SUBJECT: Issues Regarding Class I Increment Analysis Inventories

SUBJECT: Proposed Screening Technique for Class I Increment Analysis

SUBJECT: Clarification of Region 6 Clearinghouse Request on "Proposed Screening Technique for Class I Increment Analysis"

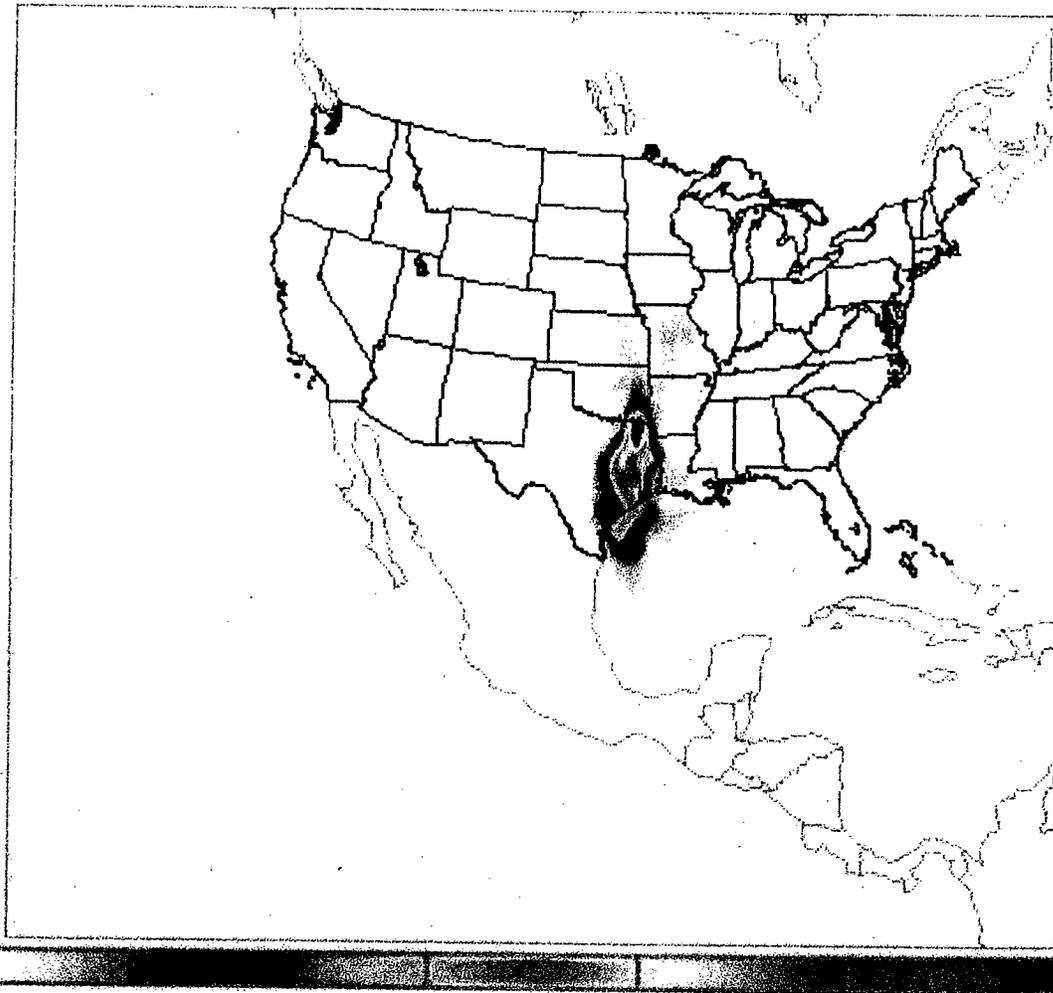
We concur with your conclusions, based on an analysis of backward trajectories to determine air mass histories on days that exceeded, that the focus for including impacts from additional sources beyond 50 km from the Class I area can be limited to the 90° sector focused on transport from the south, including the proposed facility. We see no benefit to further supplementing the inventory for sources beyond 50 km from the Class I area and outside the 90° sector. However, we also want to emphasize that such a determination could not have been made *a priori*, and can only be justified in this specific case based on the information available from the original incomplete modeling analysis.

To develop a more comprehensive understanding of the modeled increment exceedances in Caney Creek, we conducted an air mass history analysis of the CALPUFF modeling results for days when the modeled SO₂ levels were within 10% and greater of the 24-hour SO₂ increment. Using NOAA's HYSPLIT model, backward trajectories relative to the Caney Creek Class I area were run four times a day for all days at or above 90% of the 24-hour SO₂ increment. Air mass history maps were generated using a computer program developed by EPA Region 7. The maps indicate the probability of an air mass passing over a particular region prior to arrival. Used in this context, the air mass history maps provide an indication of potential source regions on days when the modeled SO₂ increment is near or exceeds allowable levels. The air mass history maps indicate two significant areas of potential influence on the high days in Caney Creek. The area of highest probability extends predominantly south from Caney Creek towards eastern Texas and Western Louisiana. This area is in the same general area as the proposed AEP source upwind of the Class I area. Previous PSD modeling for the Western Farmers Hugo Unit 2 in Oklahoma also identified this area as an area of concern for days near or above the 24-hour SO₂ increment, reinforcing the necessity to adequately capture potential increment impacts from sources that lie within that region.
